RE: SES Solar One Project
Applicant's Responses to the CEC Memo Regarding Transmission Line Upgrades

SES Solar One
Response to CEC Memorandum
Docketed 12/8/2009
08-AFC-13

TECHNICAL AREA: TRANSMISSION LINE UPGRADES

PROJ. NO: 27658189.40007

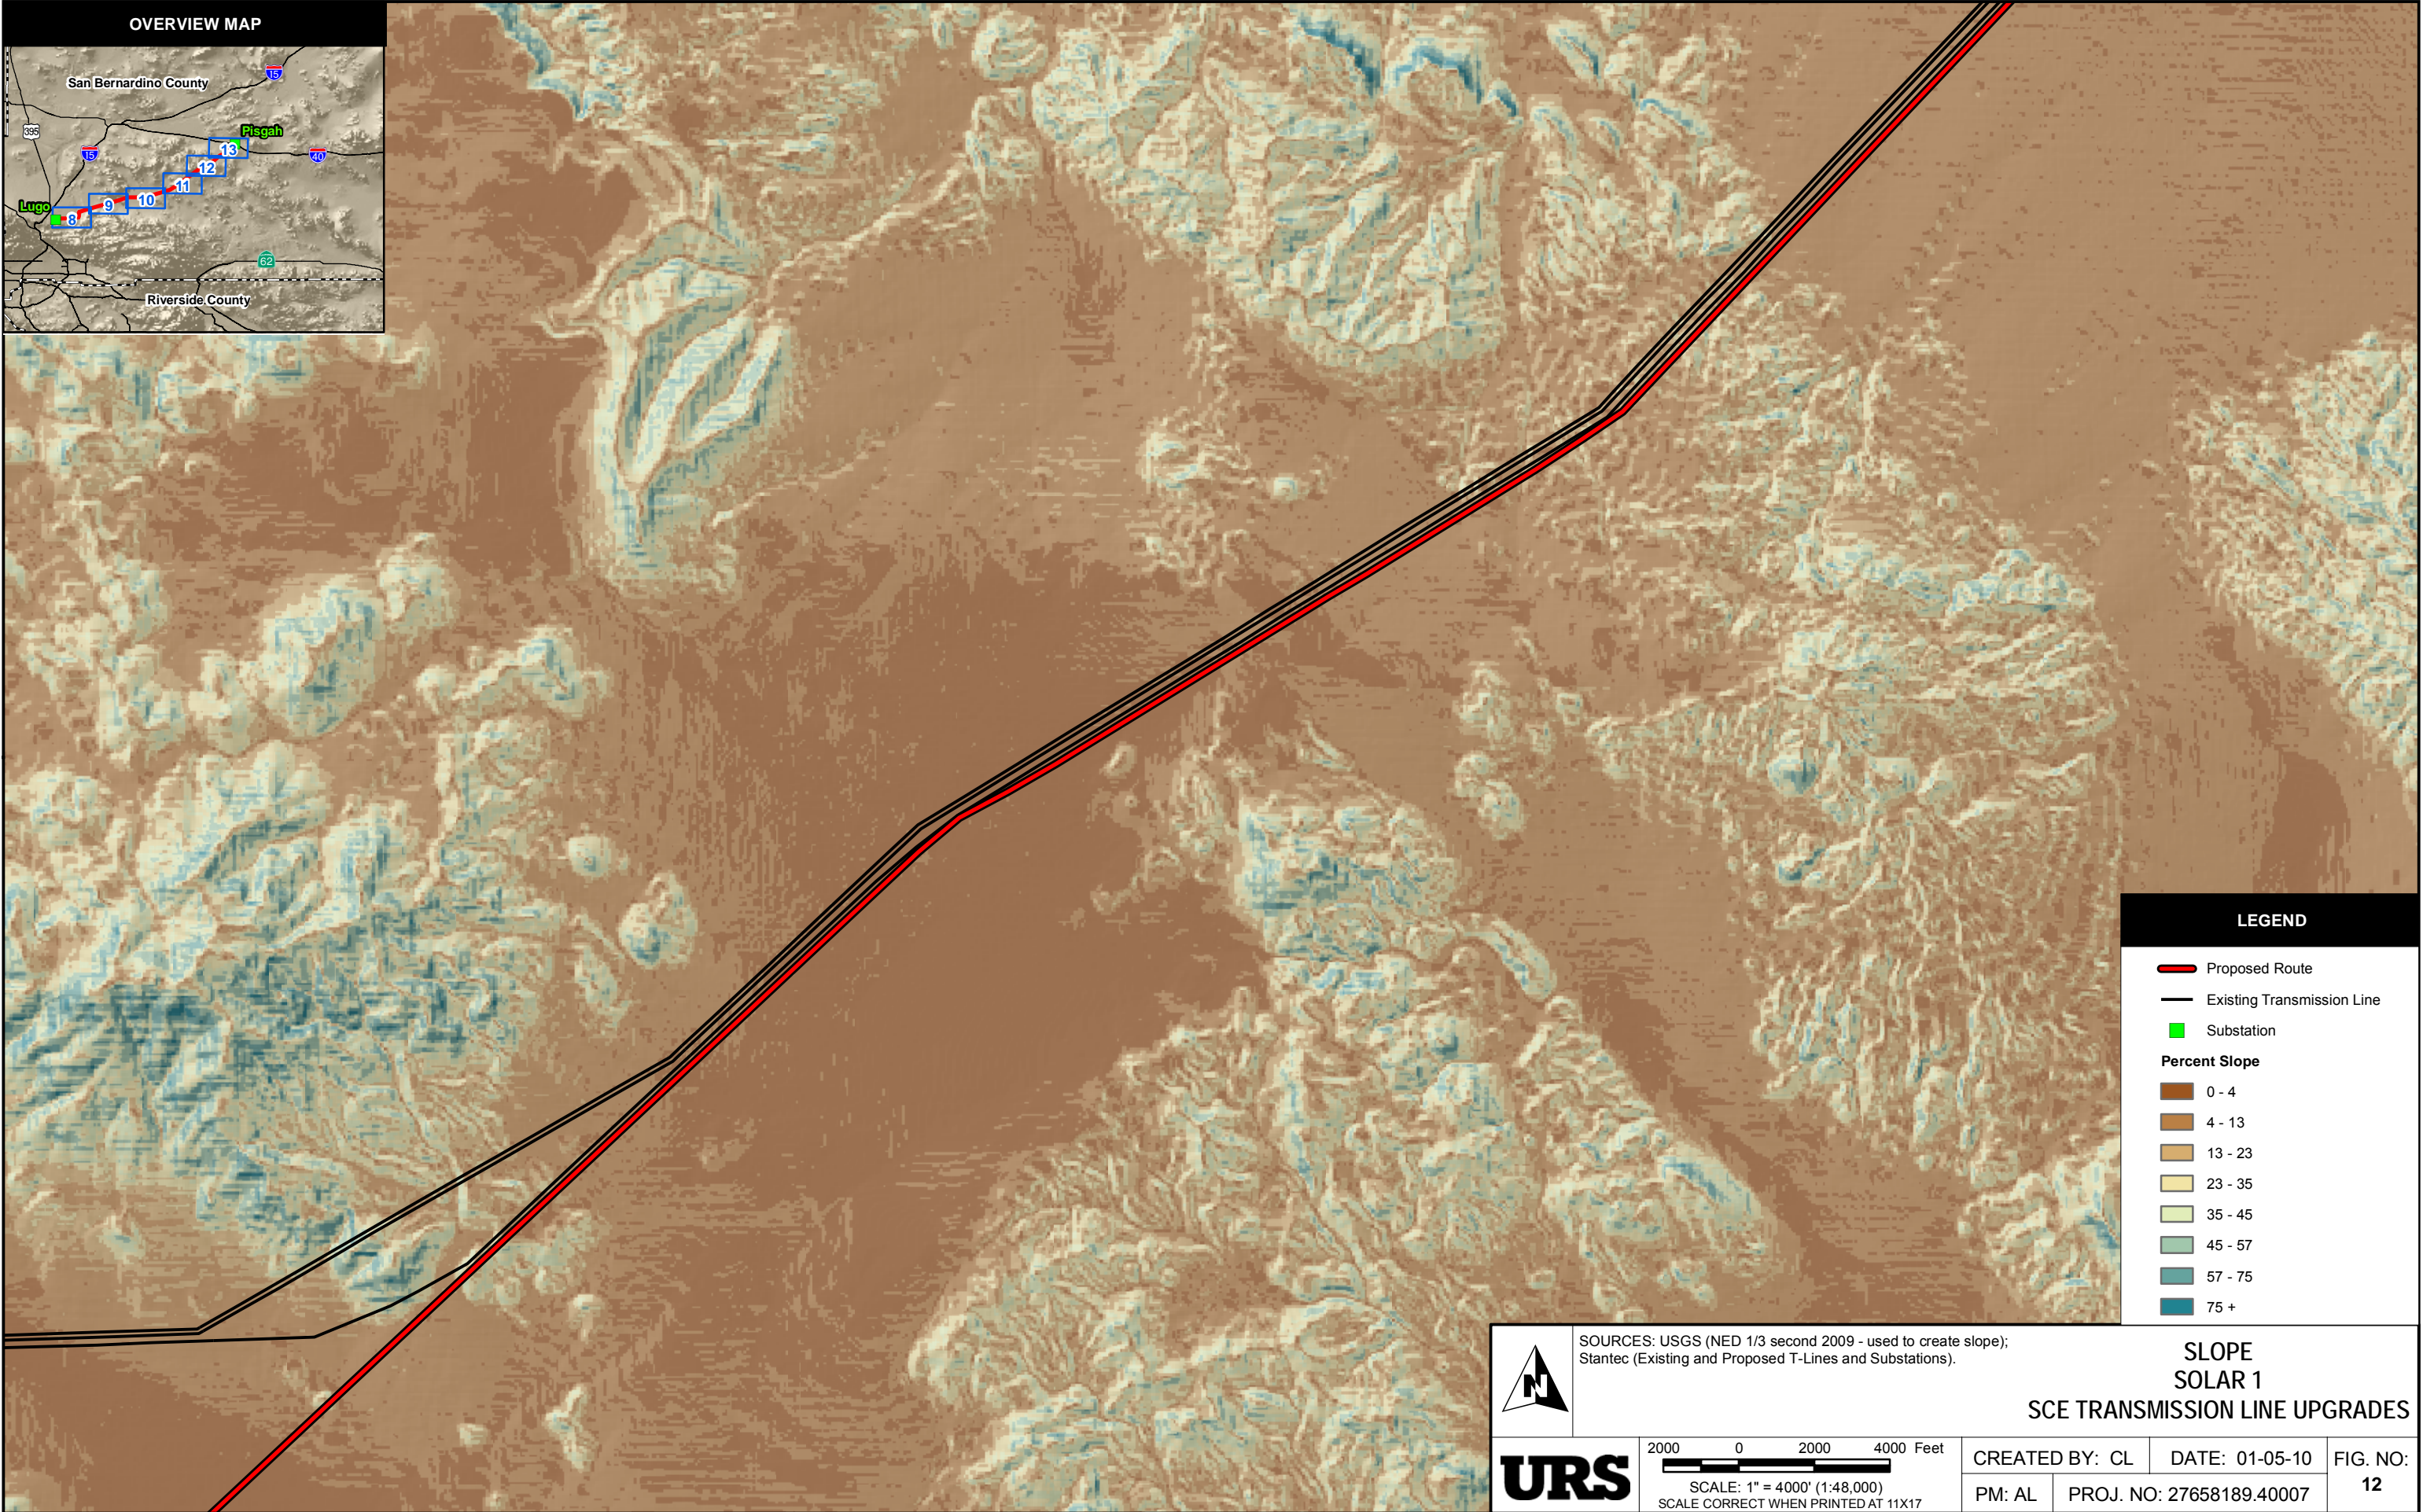
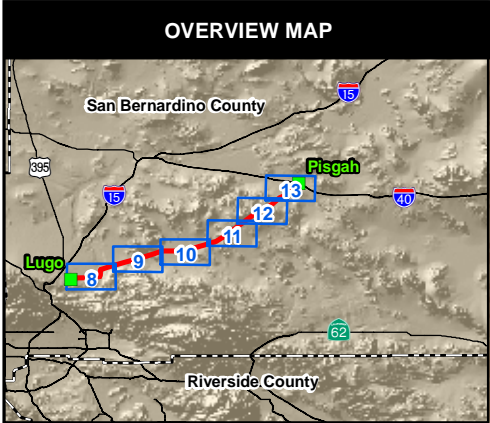
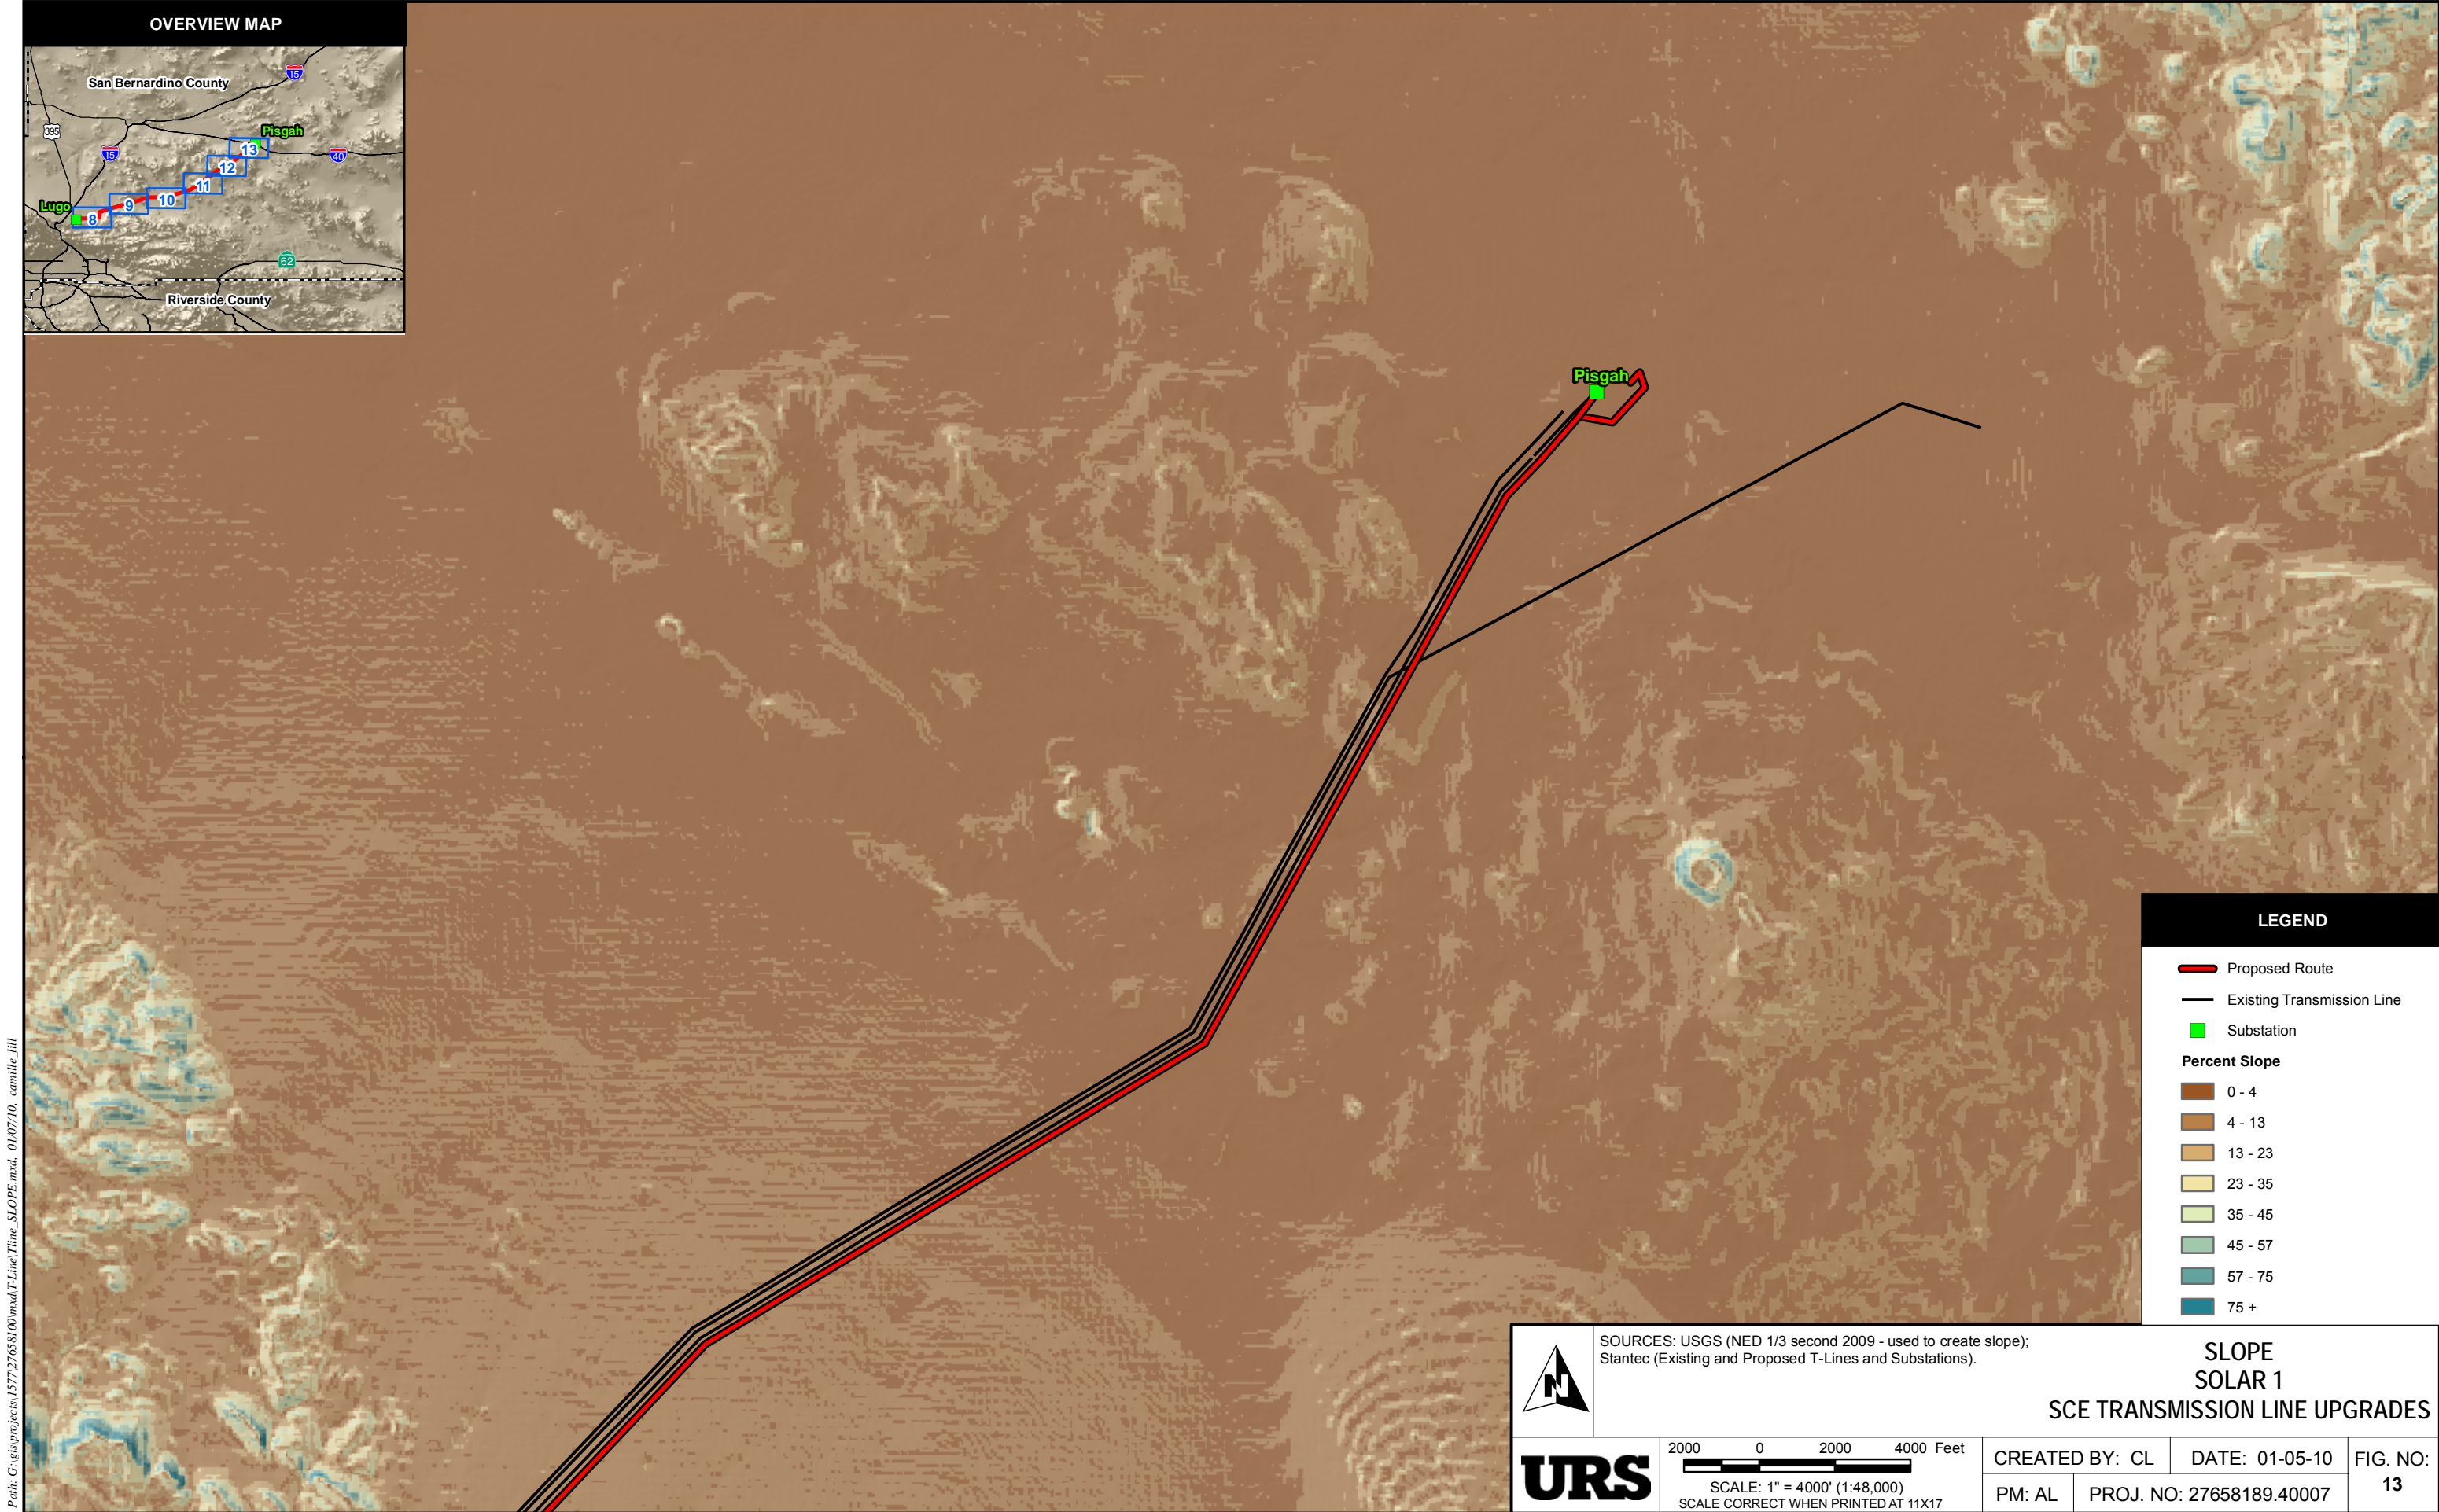
Item 10: Provide the slope gradients traversed by the alignments of transmission line upgrades and roads.

Response: Slope gradients for the proposed alignments (as shown in the AFC) and roads are depicted in attachment TRANS-5.
